U. S. NUCLEAR REGULATORY COMMISSION

Report No: 50-331/99014(DRP)

Facility: Duane Arnold Energy Center

Dates: November 11 through December 21, 1999

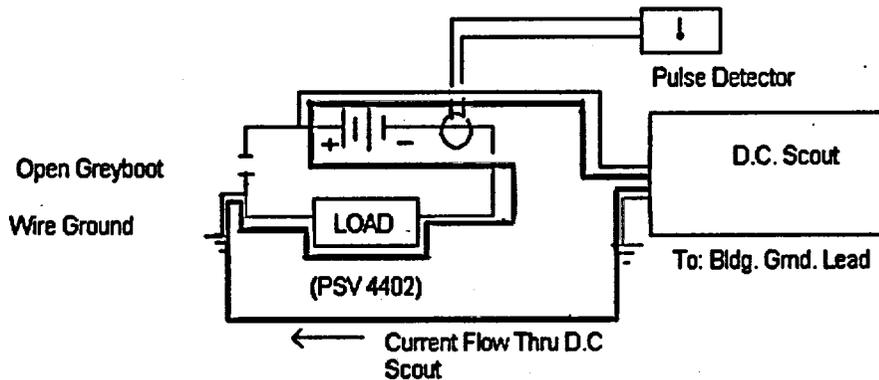
Electrical maintenance technicians were troubleshooting a ground on the 125 VDC Division I electrical system at the time of the relief valve lifting. The system's in-line ground detection system indicated a ground on the negative portion of the circuit. Electrical maintenance technicians were using a "non-intrusive" ground detection device (DC Scout) to locate the source of the ground. The ground detection device had narrowed down the ground to a DC power sub-panel. As directed by the vendor manual, electrical maintenance technicians had tied the DC Scout input lead into the positive side of the 125 VDC system. The DC Scout output lead was tied into the building ground. When amperage allowed through the DC Scout was increased to 50 milliamperes, the pilot solenoid valve for relief valve PSV 4402 actuated. The reason the pilot valve actuated was because there was also an open environmentally qualified wire splice, known as a greyboot connection, at the pilot valve in addition to the ground. The greyboot connection was open on the positive side of the pilot solenoid. This masked the fact that the ground was also on the positive side of the pilot valve circuitry. This resulted in the electrical maintenance technicians erroneously connecting the DC Scout ground detection device to the positive bus.

The simplified diagram above shows the 125 volt system with the actual system faults and the DC Scout ground detection device as it was installed. The heavy line represents the current and flow-path which caused actuation of the pilot solenoid valve. The inspector's review of the vendor manual found that the electrical maintenance technicians connected the DC Scout in what would be considered the proper manner to troubleshoot the ground as indicated by the 125 VDC system's ground detection system.

The inspectors found that the licensee had followed an approved methodology for troubleshooting electrical grounds in the wiring for main steam line relief valve PSV 4402, which spuriously lifted during troubleshooting. However, the licensee's corrective actions to properly re-install wiring pulled from the junction box supplying power to relief valve PSV 4402 prior to the relief valve lifting was inadequate. Electrical maintenance technicians failed to examine wiring inside the junction box or conduit box.
